WASHINGTON DC METROPOLITAN POLICE MEMORIAL AND MUSEUM REVISED APPROVED CONCEPT - JULY 19, 2018

SUBMISSION TO US COMMISSION OF FINE ARTS MAY 6, 2021

In its meeting of 19 July, the Commission of Fine Arts reviewed a concept proposal for the rehabilitation and expansion of the D.C. Metropolitan Police Memorial, located near the northwest corner of the Henry J. Daly Building at 300 Indiana Avenue, NW. The Commission approved the concept with the following comments for the further development of the proposal.

RESPONSE TO RECOMMENDATIONS

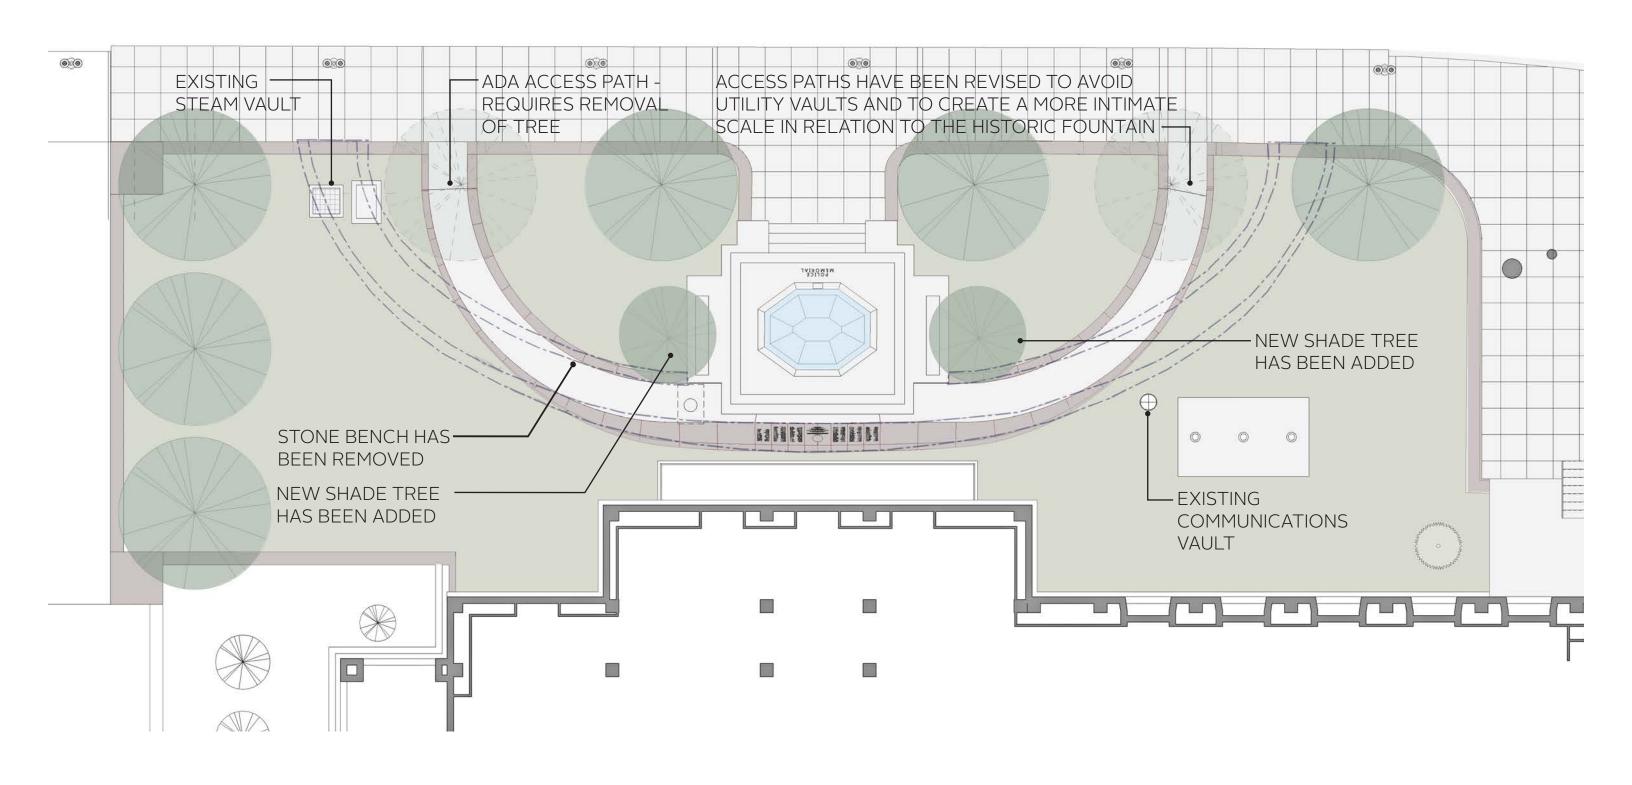
• CREATE INTIMATE SCALE THAT IS COMPATIBLE WITH THE EXISTING HISTORIC FOUNTAIN

STUDY THE LOCATION OF THE INSCRIPTIONS IN RELATIONSHIP TO THE EXISTING HISTORIC FOUNTAIN

ELIMINATE STONE BENCHES ALONG THE NEW WALKWAY

Memorial layout has been revised.

See inscription layout and section.

Stone benches have been eliminated.

- PROVIDE SHADE TREES
 Shade trees have been provided.
- PREPARE GROUND-LEVEL PERSPECTIVE VIEWS
 See perspective views.
